**THE  
NATIONAL  
BOARD**  
OF BOILER AND  
PRESSURE VESSEL  
INSPECTORS

**NATIONAL BOARD  
INSPECTION CODE  
COMMITTEE**

***AGENDA March 18 and 19, 2014***

*Meeting of Sub Group Locomotives  
Location 1055 Crupper Ave  
Columbus, OH 43229*

SEAL WELDING OF BOILER FLUES  
EXPANDED BY STRAIGHT ROLLING

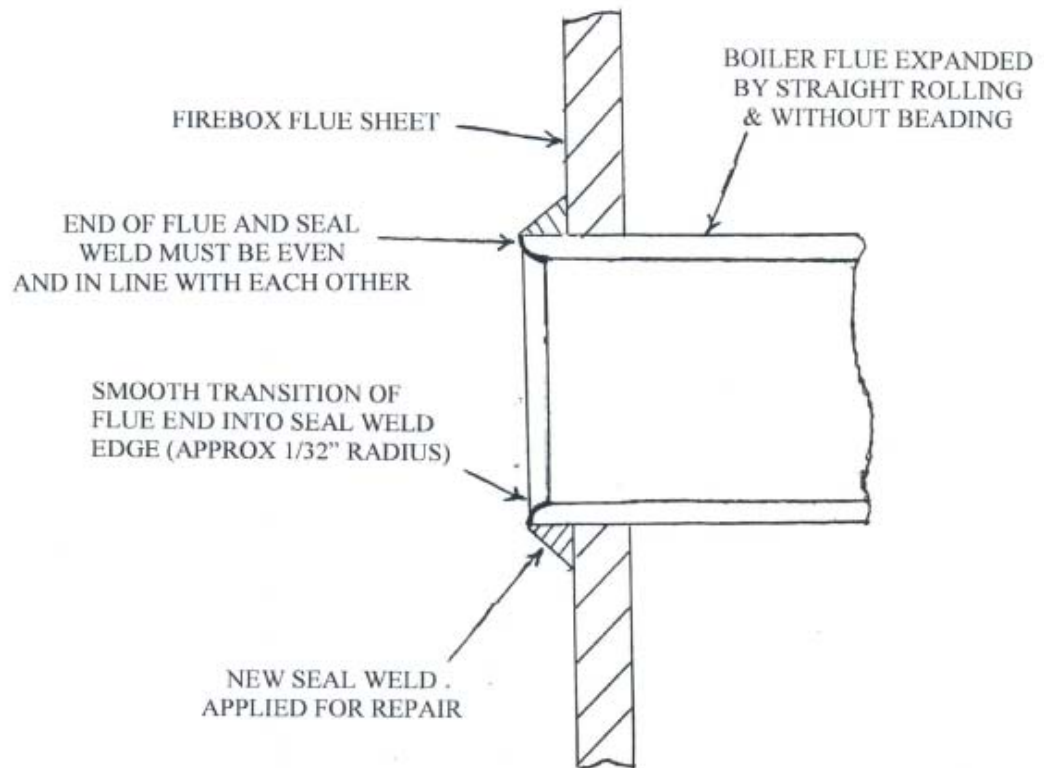
1. Each Flue shall be expanded either partially or completely into the flue sheet hole prior to seal welding. Upon completion of seal welding the flue shall be expanded to the final setting or re-expanded lightly to confirm the seal welding has not loosened it.

2. Changing the method by which flues are installed from prossering and beading to expanding straight and seal welding shall be considered a repair.
3. Changing the method by which flues are expanded from the prosser method to the roller expander method shall be considered a repair.

4. When flues are installed by expanding straight and seal welding, the outer tube edge shall be even with the outer seal weld edge. All sharp edges of the flue and seal weld shall be smoothed and rounded by filing, sanding, or grinding. Care shall be used to prevent tearing or overheating the tube.

5. Flues that show cracks upon completion of the installation process shall be replaced. Repair is prohibited.
6. When flues are beaded, the bead edge shall contact the flue sheet around the entire flue circumference. Repair of a defective or incorrectly formed bead by welding is prohibited.

## STEAM PIPES & SUPERHEATER ARRANGEMENT

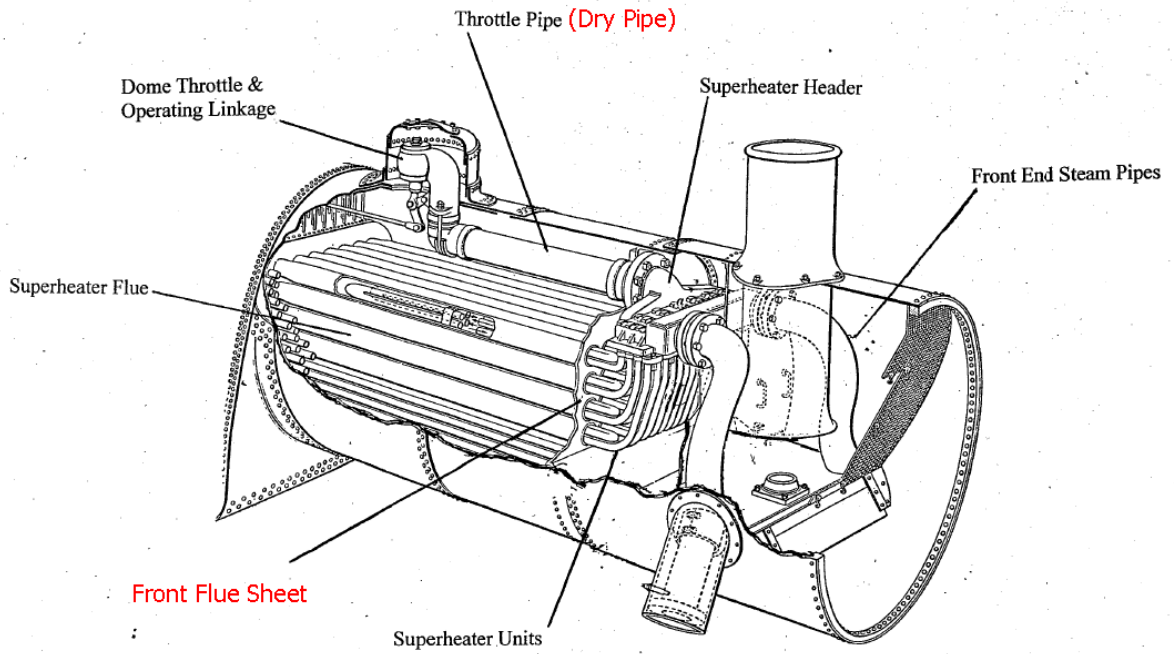
<u>Name</u>	<u>Comment</u>	<u>Date Created</u>
Bob Reetz	<p>First, change the location from S1.2.9 to S1.2.14 and name the figure as "Figure S1.2.14". After the title, add "(See Figure S1.2.14)". Second, change "are" to "is" in 1) and 2). Third, reword the last sentence in 1) to read "Repair is prohibited, but pinholes and defects not exceeding 0.25 inches in length or width may be repaired by brazing. "Fourth, reword the third sentence in 3) to read "All welded repairs shall be done in accordance with NBIC Part 3 and ASME Section I Part PW." Fifth, in 3) add "replaced" at the end of the second sentence. Sixth, in 4)change "radiographically" to volumetrically". Lastly, we need metric equivalents added where needed. Should these items be addressed, I will change my vote to "approve".</p>	07/23/2013

J. David Conrad	<p>Repairs to cracks in cast iron superheater headers and admission pipes are sometimes possible with brazing or metal stitching.</p>	07/11/2013
Robert Yuill	<p>Section 4; change radiographic examination to volumetric examination, or add volumetric examination to the radiographic examination. I question the practicality of RT on some of the header areas. UT will provide another method in inspection. Section 1; is the repair of any defects anywhere on a cast iron header prohibited, or only in the pressure containing areas. Could flanges or tee slots be repaired?</p>	07/10/2013
Linn Moedinger	<p>I agree with the overall proposal, however in the case of cast iron pipes, I believe we need to address the common issue of pitting which is usually present from the foundry. These isolated pits can corrode through the pipe creating a</p>	07/10/2013

Regarding the repair of superheater headers – TVRM successfully repaired the flange of a T-slot header (non-pressure boundary) so I agree that this kind of repair should not be disallowed. Also, what about repairs to throttle flanges? TVRM is currently having a pattern built to reproduce the balanced throttle used by Southern Railway (both the 2-8-0's and 2-8-2's used this throttle). This is being done because a recently unearthed drawing of the throttle verified how wore out the components were. No recovery is possible since all the parts are cast iron.

The project manager of this action item, Mr. Richard Stone has examined the comments received and has developed a revised document to be letter balloted this week.

# STEAM PIPES & SUPERHEATER ARRANGEMENT

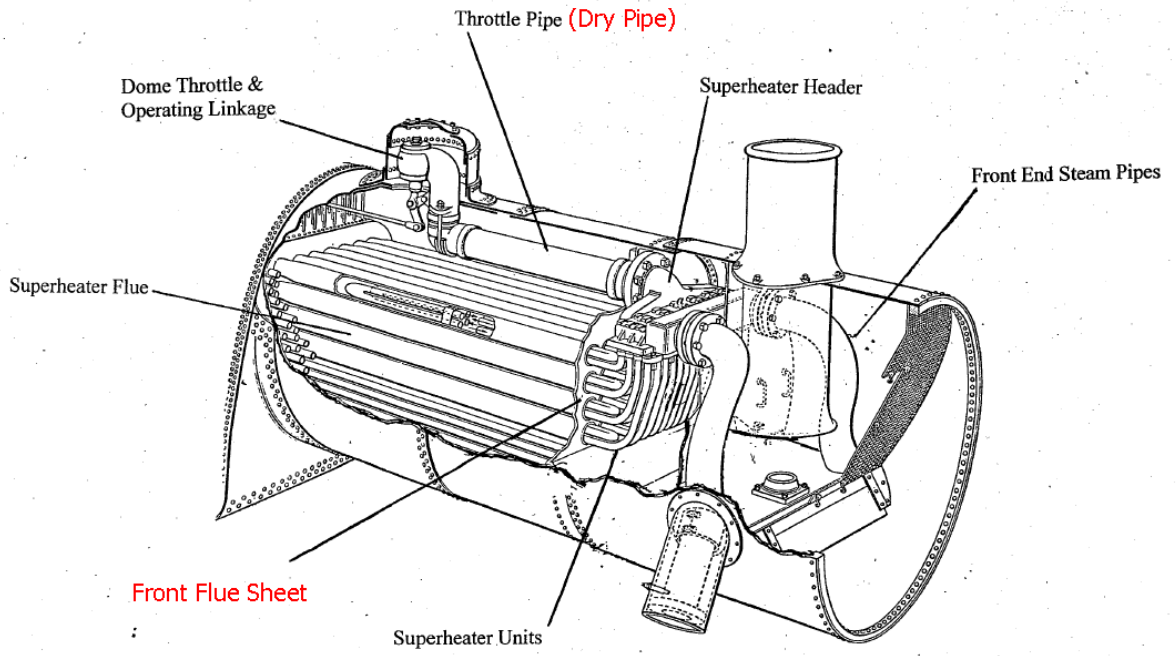
<u>Name</u>	<u>Comment</u>	<u>Date Created</u>
Matt Janssen	In reading Mr. Conrad's comments I do not feel sufficiently informed on the background statement to support this ballot. In 1), there appears to be a contrast between the first and second sentence as to what size crack can actually be repaired. I also believe the first sentence should be "that have cracks" instead of "and have cracks..." I agree the drawing is very helpful, however, I am unsure about the continuity of "flue sheet" vs. "tubesheet" terms. I think this is a nice item and I would approve it if I understood the crack size (<2" x .25"?) as well as had clarification on the background statement.	10/13/2013

J. David Conrad	I agree with the text of the proposal as re-modified. I continue to disagree with the "Background" reason given. The examples cited were not failures of repairs, rather they were failures of old parts which were not inspected using methods currently required.	10/08/2013
Bob Reetz	I like the illustration included as those not familiar with the design of locomotive boilers or with the terminology used will quickly understand the issue.	10/03/2013

- 1) Throttle pipes, dry pipes, superheater headers, and front end steam pipes made from cast iron ~~or wrought iron that are cracked~~ and have cracks greater than 0.25 inches (6 mm) in length or width or have corroded to less than the minimum allowable thickness shall be removed from service. ~~Repair is prohibited.~~ Cracks not exceeding 1.00 inches (25.4 mm) in length or 0.25 inches (6.4 mm) in width may be repaired by brazing. Pinholes and defects not exceeding 0.25 inches (6.4 mm) in diameter may be repaired by brazing. Repair by welding is prohibited.

- 2) Cracks in throttle pipes, dry pipes, superheater headers, and front end steam pipes made from steel ~~that are cracked~~ may be repaired by welding. All welded repairs shall be done in accordance with NBIC Part 3 and ASME Section I Part PW. The welds shall be the full penetration-type and shall be volumetrically examined.

- 3) Weld build-up may be used for repair of steel components provided if the corroded section does not exceed 10 square inches (64.52 square centimeters) in area and the depth of corrosion is less than 50% of the original wall thickness. If the corrosion depth or area exceeds one or both of these values, either the corroded section shall be replaced by a new section installed using full penetration welds or the entire component replaced. All weld build-up welded repairs shall be done in accordance with NBIC Part 3 and ASME Section I Part PW. All welds shall be volumetrically examined. If weld build-up is done in the interior of components subject to steam flow, the interior welded surfaces shall be ground smooth to prevent forming edges between the original and repaired surfaces.

- 4) When ~~cracks are repaired or~~ new replacement sections are installed in steel components the interior edges of the new and original surfaces subject to steam flow shall be set even with each other to prevent edges. All the welds shall be the full penetration-type, shall be done in accordance with NBIC Part 3 and ASME Section I Part PW and be volumetrically radiographically examined. Replacement flanges may be installed by welding in accordance with NBIC Part 3 and ASME Section I Part PW.

- 5) Throttle pipes, dry pipes, superheater headers, and front end steam pipes shall be supported by hangers or other structural means to prevent placing bending loads on the adjacent mating parts and attachment studs. All pins, bolts and nuts used to attach these parts to each other and to the boiler shall be equipped with a mechanical retainer such as a cotter pin or be fitted with double nuts, to prevent loosening.
